**ADDENDUM NO. 3
TO THE
SPECIFICATIONS, PROPOSAL, AND CONTRACT DOCUMENTS**

**TOTEM LAKE CONNECTOR BRIDGE
JOB # 01-20-PW/NMC0861000**

CITY OF KIRKLAND, WASHINGTON

ITEM NO. 3: Revised Plan Sheets

CITY OF KIRKLAND
TOTEM LAKE PEDESTRIAN BRIDGE
 DEMOLITION AND EROSION CONTROL PLAN 1

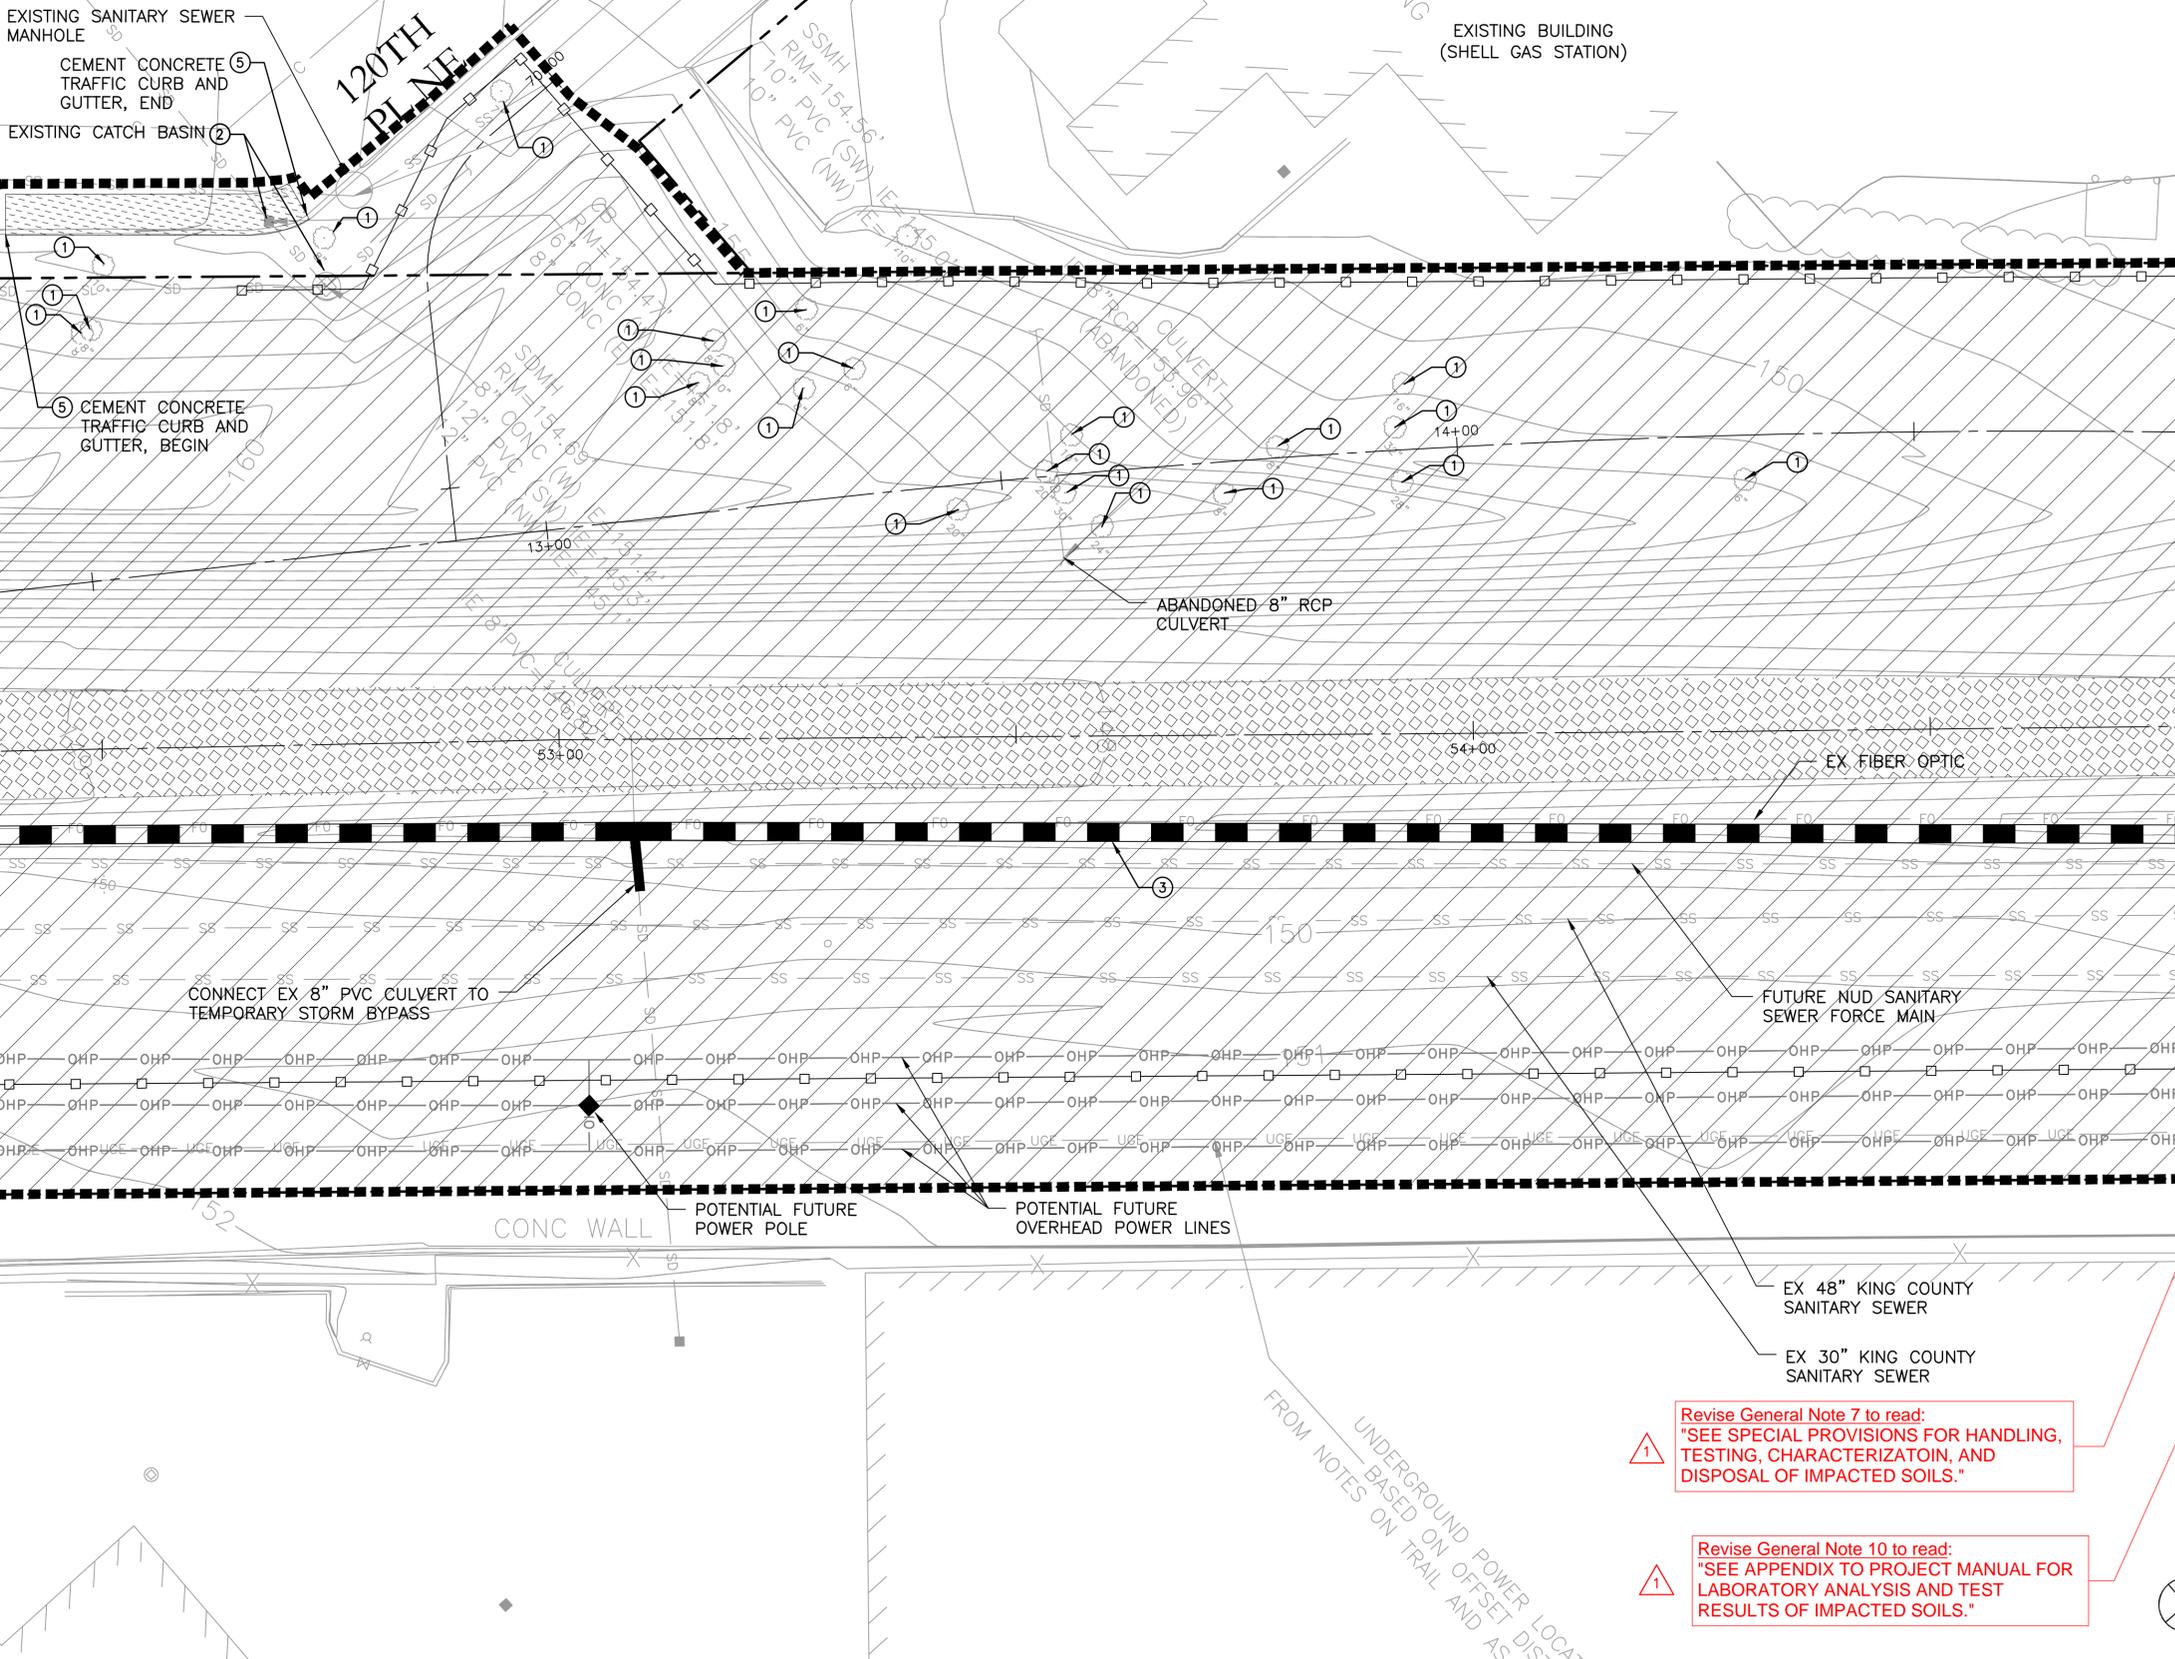
1. **Revise General Note 7 to read:**
 "SEE SPECIAL PROVISIONS FOR HANDLING, TESTING, CHARACTERIZATION, AND DISPOSAL OF IMPACTED SOILS."

1. **Revise General Note 10 to read:**
 "SEE APPENDIX TO PROJECT MANUAL FOR LABORATORY ANALYSIS AND TEST RESULTS OF IMPACTED SOILS."

CITY OF KIRKLAND
 TOTEM LAKE PEDESTRIAN BRIDGE
 DEMOLITION AND EROSION CONTROL PLAN 2

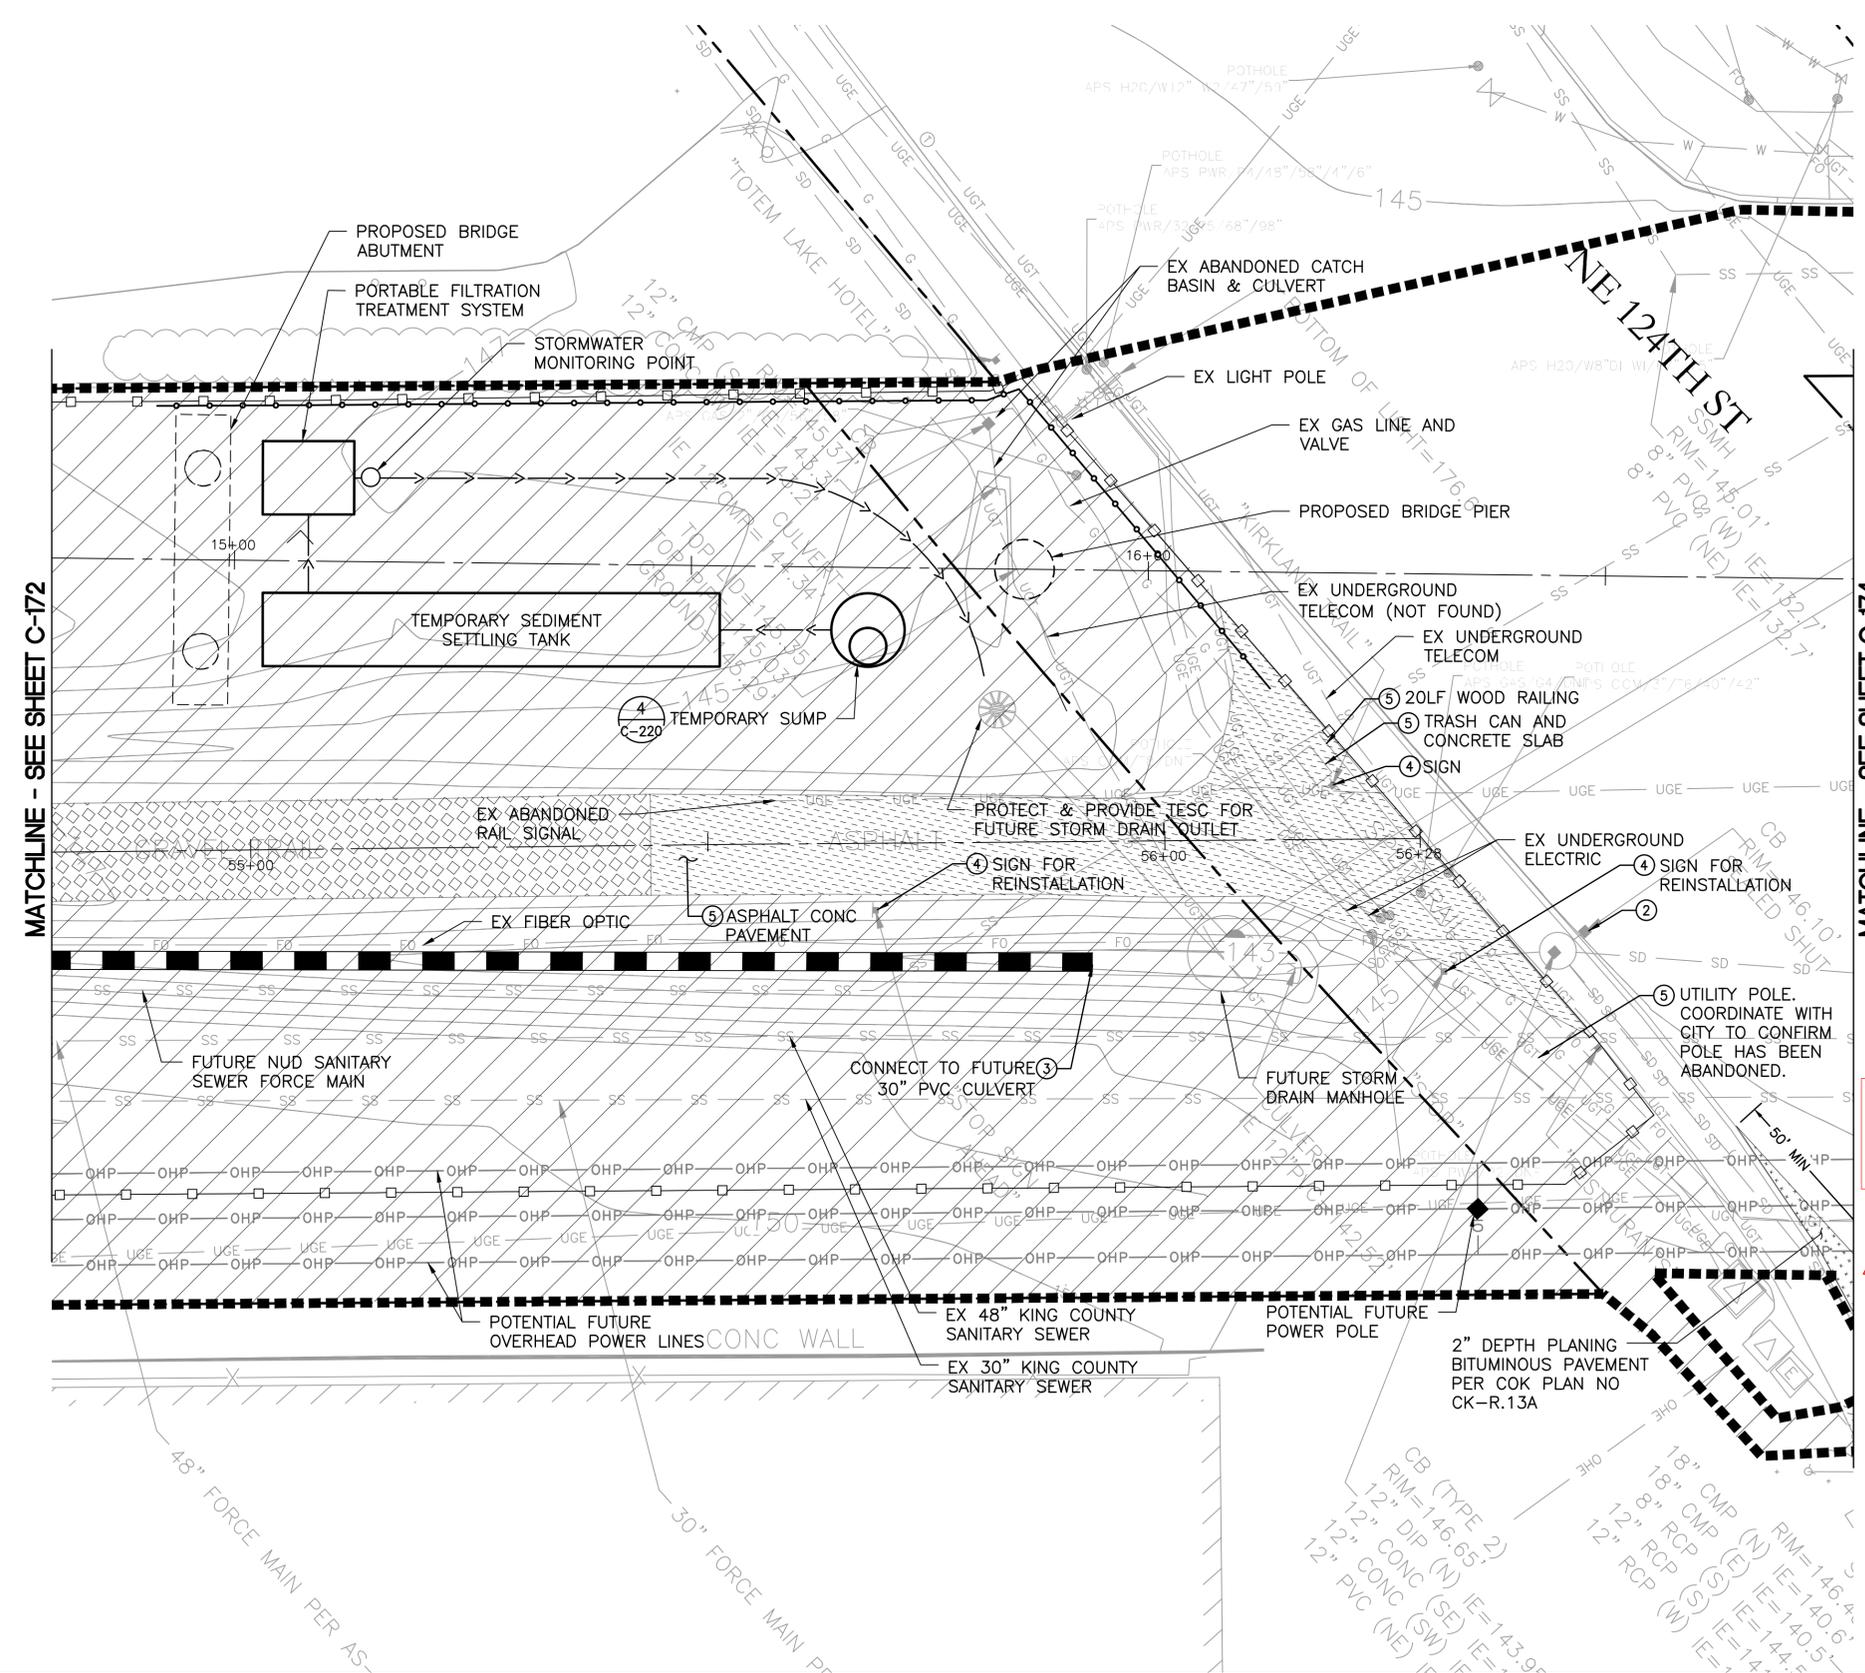
⚠ **Revise General Note 7 to read:**
 "SEE SPECIAL PROVISIONS FOR HANDLING, TESTING, CHARACTERIZATION, AND DISPOSAL OF IMPACTED SOILS."

⚠ **Revise General Note 10 to read:**
 "SEE APPENDIX TO PROJECT MANUAL FOR LABORATORY ANALYSIS AND TEST RESULTS OF IMPACTED SOILS."

CITY OF KIRKLAND
TOTEM LAKE PEDESTRIAN BRIDGE
 DEMOLITION AND EROSION CONTROL PLAN 3

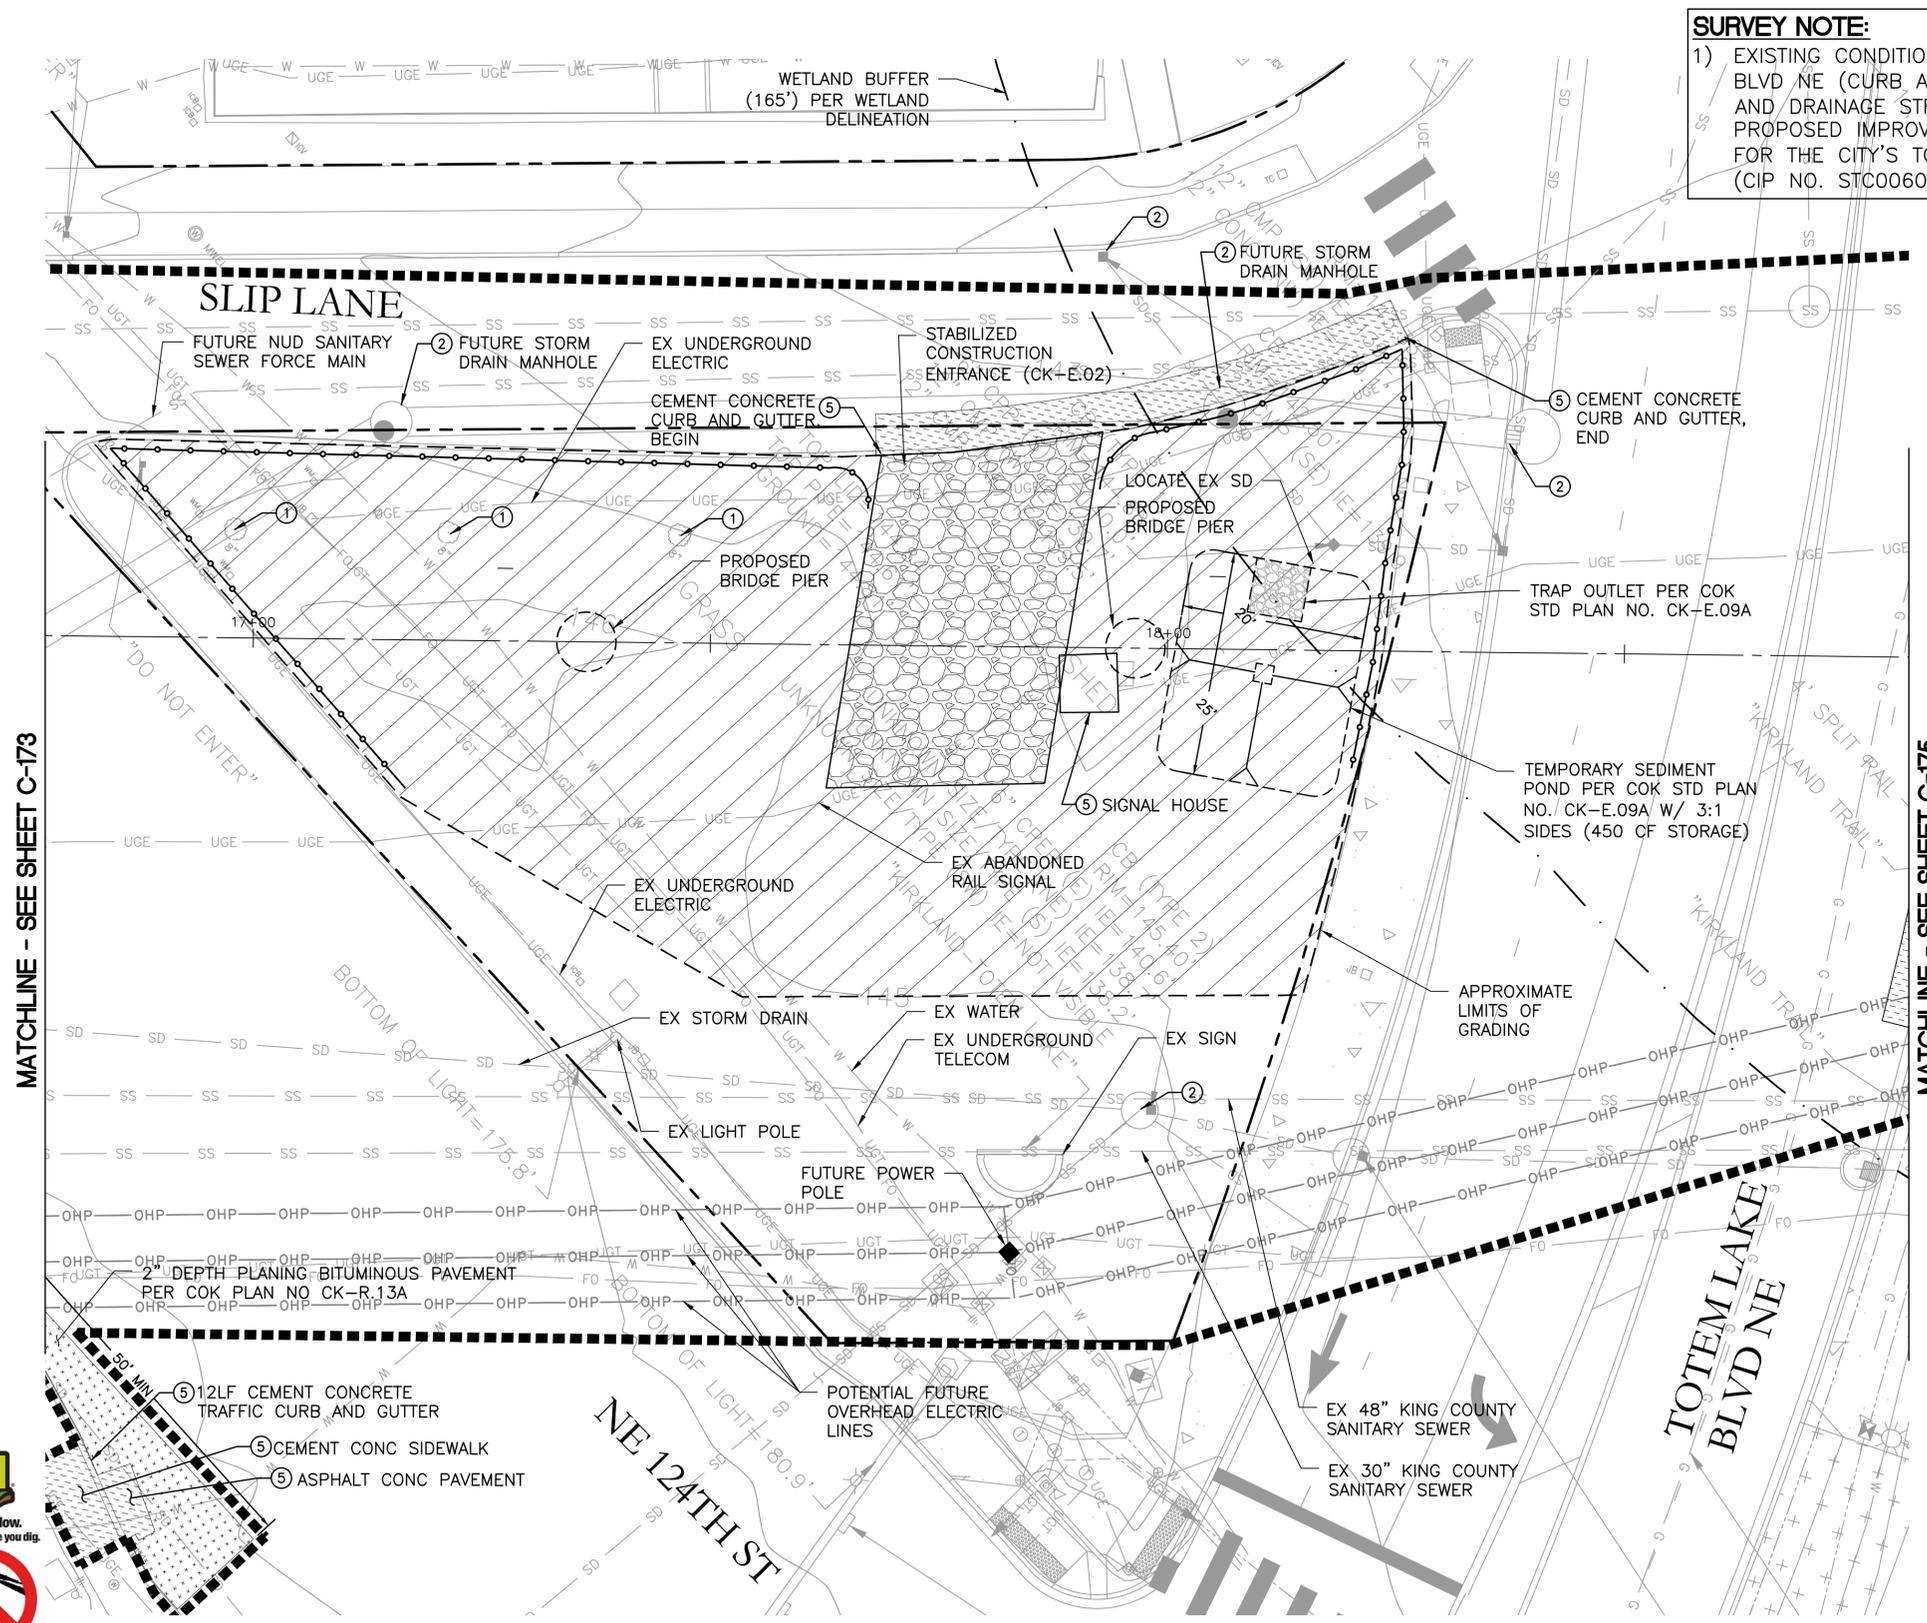
⚠️ **Revise General Note 7 to read: "SEE SPECIAL PROVISIONS FOR HANDLING, TESTING, CHARACTERIZATION, AND DISPOSAL OF IMPACTED SOILS."**

⚠️ **Revise General Note 10 to read: "SEE APPENDIX TO PROJECT MANUAL FOR LABORATORY ANALYSIS AND TEST RESULTS OF IMPACTED SOILS."**
